# OPTIREG™ PMIC TLF35584QVHSx

## Functional Safety Power Management IC

### Errata Sheet

Reference: Datasheet Rev 2.0 (TLF35584QVHSx)

Figure 1 Interrupted SYN output for activated spread spectrum (FRE pin to GND - LF)

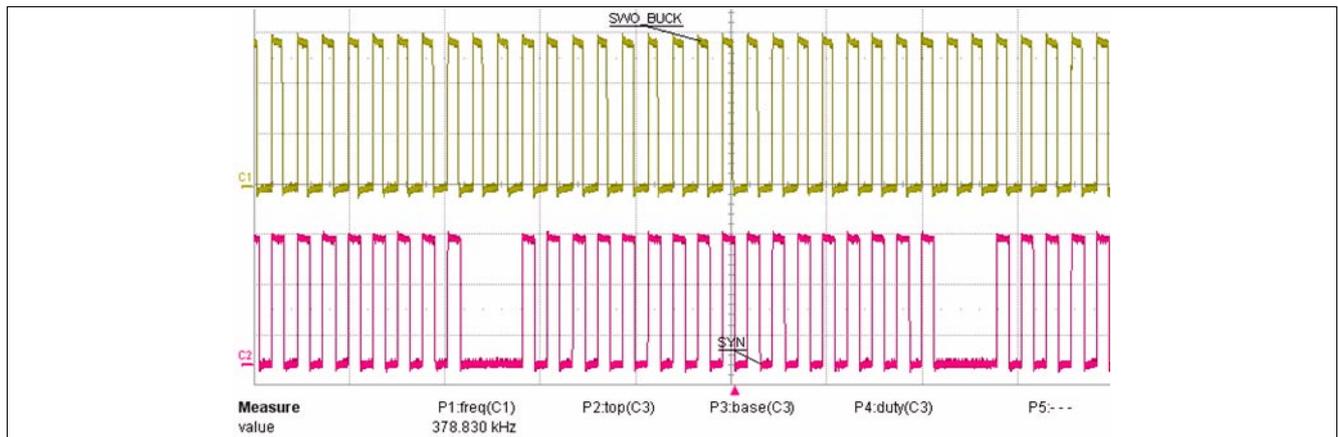
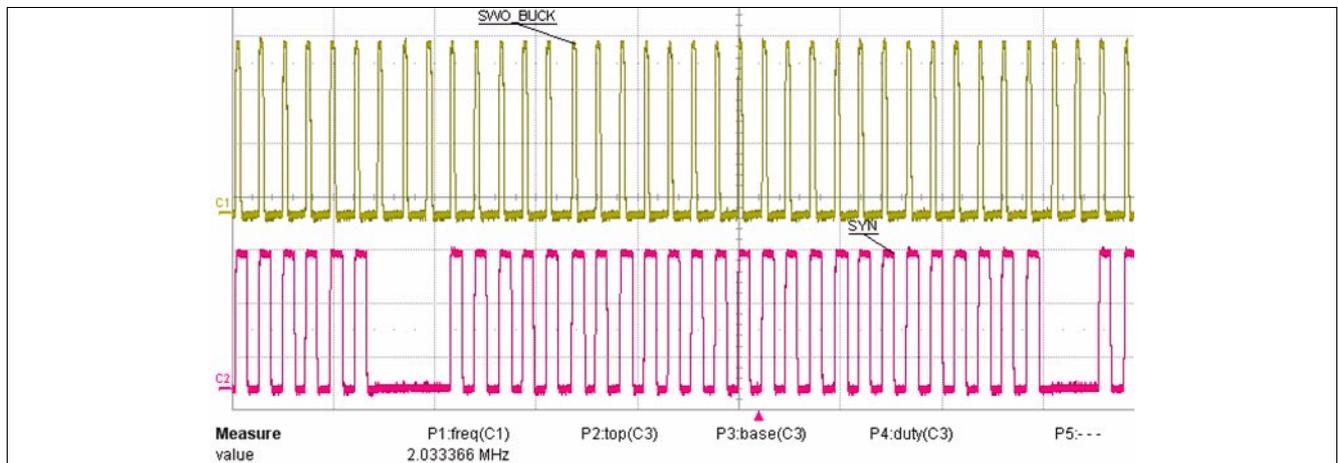
Number	Function	Description
1	Synchronization output signal with active spread spectrum	<ul style="list-style-type: none"> <li>There is a weakness of the D11-step silicon for the synchronization output signal for the optional core voltage regulator during activated spread spectrum.</li> <li>In case the synchronization output SYN is being used and connected to an external switched mode power supply, it should be taken into consideration that the SYN-output signal might be interrupted unintentionally in a random way for activated spread spectrum.</li> <li>In <a href="#">Figure 1</a> and <a href="#">Figure 2</a> it is shown how the signal of SYN might look like. The figures have been generated using the synchronization without phase shift (DEVCFG2.ESYNPHA = 0). For this configuration the SYN output signal will stuck to low signal temporarily. For configuration with 180° phase shift (DEVCFG2.ESYNPHA = 1) the stuck signal would be high level.</li> </ul>

**Figure 3** Reset Output (ROT) weakness - Example: Short to GND detection of QUC

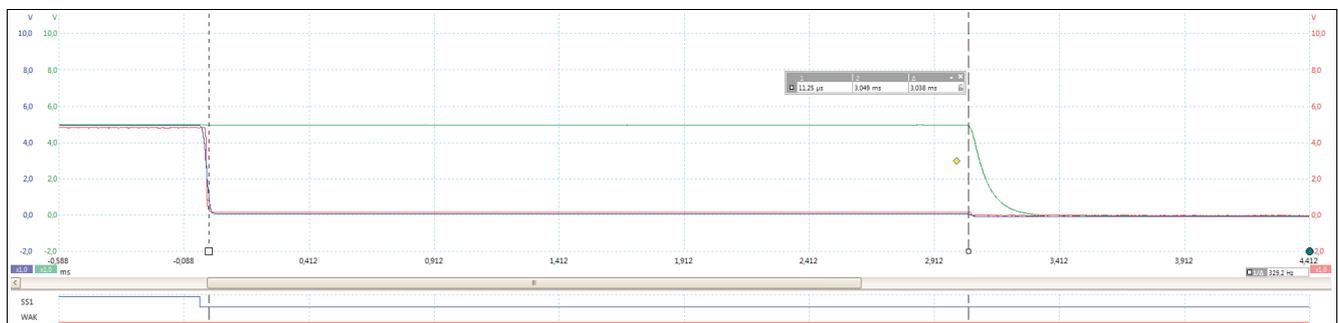
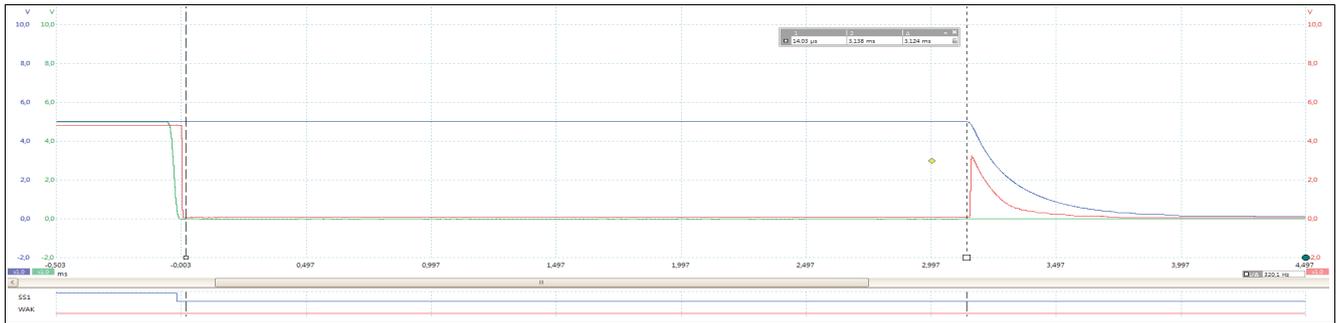
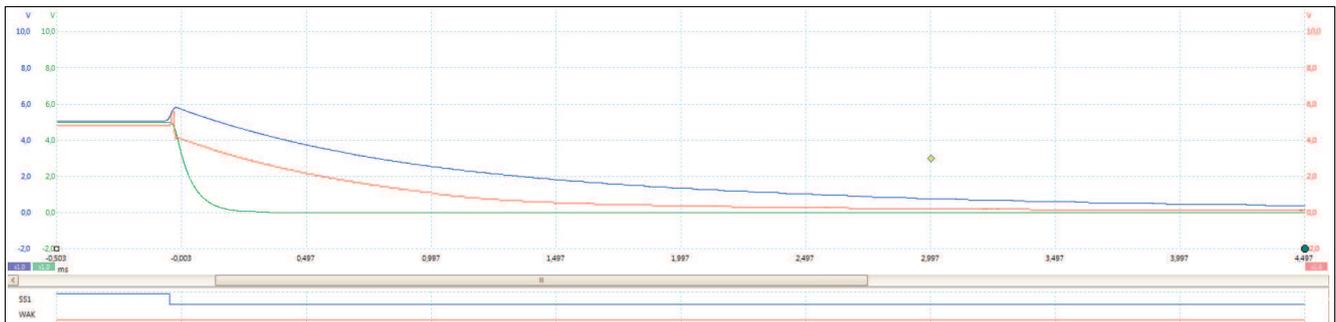
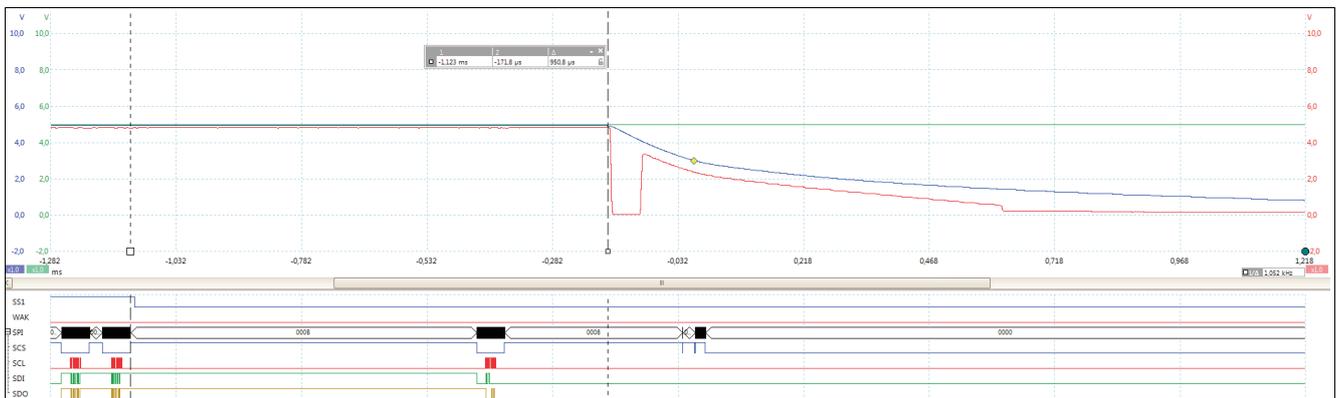
Number	Function	Description
1	Reset output ROT behavior in Move-to-FAILSAFE conditions	<ul style="list-style-type: none"> <li>• There is a weakness of the D11-step silicon related to the reset output pin ROT, in case the TLF35584 moves to FAILSAFE state. In a safety context the reset function and the reset output ROT are considered to be QM, accordingly safety is not affected.</li> <li>• The output driver of the open drain transistor in the reset output ROT is disabled together with the microcontroller supply LDO (QUC). According to the fact that the QUC is disabled/switched off in case of a Move-to-FAILSAFE event, the reset output is not longer pulled to low signal and is pulled up to QUC. As the QUC is disabled and the output cap is discharged by the load and an internal active pull-down of <math>\sim 80 \Omega</math>, this is reflected in a transient behavior which is shown in the figures below. The observation and relevance strongly depends on the failure case and its boundary conditions. These conditions are elaborated in the following list. <ul style="list-style-type: none"> <li>– QUC shorted to GND: The voltage monitoring detects the UV and pulls down ROT. SS1/2 are going low and application is in safe state. QUC is shorted to GND and has 0V accordingly, but provides current (still enabled). After typ. 3ms TLF35584 moves to FAILSAFE state and disables the LDO and resets the output driver of ROT. Due to the short to GND ROT stays low as it is pulled to QUC. (no problem) Please refer to <a href="#">Figure 3</a>.</li> <li>– QUC overloaded by current. The voltage monitoring detects the UV due to the decreased output voltage by current limitation or dropout voltage (only without boost) and pulls down ROT. SS1/2 are going low and application is in safe state. Due to the assertion of ROT the microcontroller is switched off and decreases its current consumption dramatically. The output voltage of QUC might recover into valid voltage range and the TLF35584 restarts in INIT state. (no problem)</li> <li>– Continuous UV or short to GND on QST or VCI: The voltage monitoring detects the UV on the respective rail and pulls down ROT. SS1/2 are going low and application is in safe state. QUC continues to regulate to its nominal output voltage. After typ. 3ms TLF35584 moves to FAILSAFE state and disables all LDO and resets the output driver of ROT. The reset output might be pulled up to the discharging QUC (by the attached load and an active pull-down of <math>\sim 80 \Omega</math>). This might result into a temporary high level at ROT during the shutdown transition. A undervoltage monitoring of the microcontroller could prevent undesired start of the microcontroller operation. Please refer to <a href="#">Figure 4</a>.</li> <li>– Continued on the next page.</li> </ul> </li> </ul>

Number	Function	Description
1 (cont'd)	Reset output ROT behavior in Move-to-FAILSAFE conditions (cont'd)	<ul style="list-style-type: none"> <li>Continued:           <ul style="list-style-type: none"> <li>QUC shorted to an higher voltage rail: The voltage monitoring detects the OV on the QUC rail and SS1/2 are going low and application is in safe state. TLF35584 will move to FAILSAFE which is disabling QUC as well as all other regulators and activates the active pull-down of <math>\sim 80 \Omega</math> on QUC output, trying to discharge the rail. The FAILSAFE state disables also the output driver of ROT. The reset output might be pulled up to QUC. This might result into a high level at ROT during presence of the external overvoltage. Still the application will be safely shut down during in this case by SS1/2. Please refer to <a href="#">Figure 5</a>.</li> </ul> </li> </ul>
2	Reset output ROT behavior for Move-to-STANDBY transitions	<ul style="list-style-type: none"> <li>There is a weakness of the D11-step silicon related to the reset output pin ROT, in case the TLF35584 moves to STANDBY state. In a safety context the reset function and the reset output ROT is considered to be QM, accordingly safety is not affected.</li> <li>The output driver of the open drain transistor in the reset output ROT is disabled shortly after the microcontroller supply LDO (QUC). According to the fact that the QUC is disabled/switched off at the point in time when the device enters into STANDBY state (transition delay time expired or in case of QUC current monitoring usage after a decrease below the current threshold), the reset output shortly pulled to low, but pulled up to the output voltage of QUC right after. Nevertheless the output of QUC is actively discharged by the load and an internal active pull-down of <math>\sim 80 \Omega</math>, this is reflected in a transient behavior which is shown in <a href="#">Figure 6</a> below.</li> </ul>

Figure 7 Interrupted state transition NORMAL-STANDBY (MPS pin set low)

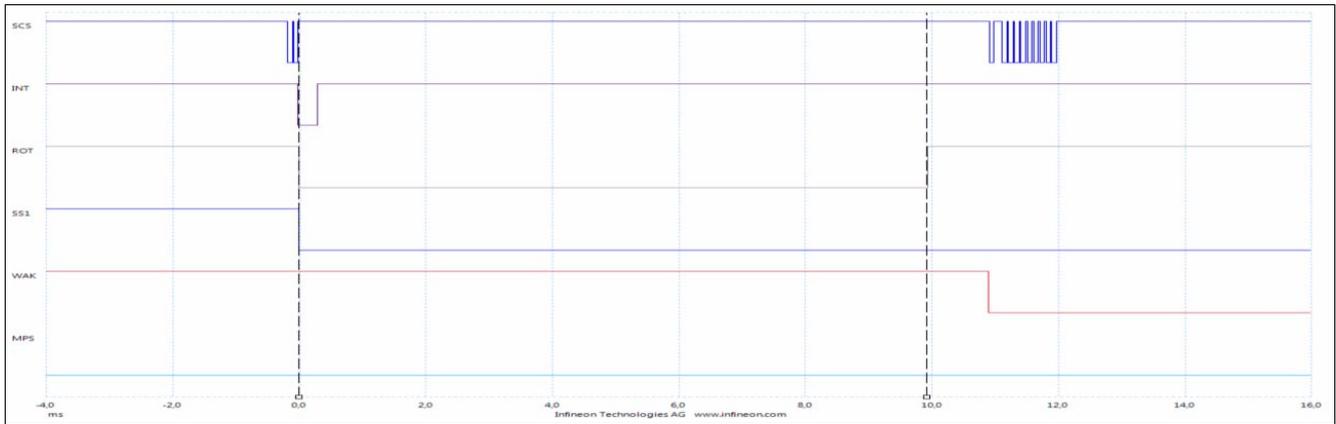
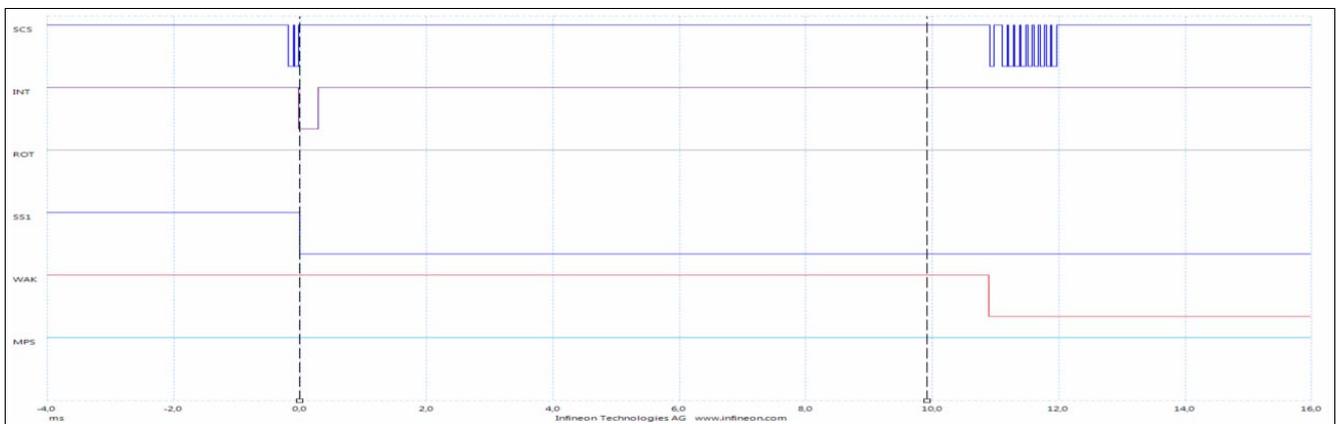
9	Microcontroller programming support (MPS) influence to state transition NORMAL/WAKE to STANDBY	<ul style="list-style-type: none"> <li>• The chapter 11.7 in the Datasheet Rev 2.0 (TLF35584QVHSx) describes influences to the overall device behavior of the TLF35584. Beside the described differences there is a unintended influences to the device behavior in case of microcontroller programming support being active (MPS-Pin high) for the movement NORMAL/WAKE to STANDBY. <ul style="list-style-type: none"> <li>– For the particular case of an interrupted state transition from NORMAL/WAKE to STANDBY due to a wake-up event by WAK (level) or ENA(edge) during the transition, the TLF35584 is not triggering ROT to low when moving to INIT state. Accordingly the behavior with and without MPS being activated can be compared by <a href="#">Figure 7</a> and <a href="#">Figure 8</a>. Nevertheless the interrupted transition is triggering in both cases an interrupt event and reports the interrupted state transition by the interrupt register IF.SYS and the subsequent diagnostic register SYSSF.TRFAIL.</li> </ul> </li> </ul>
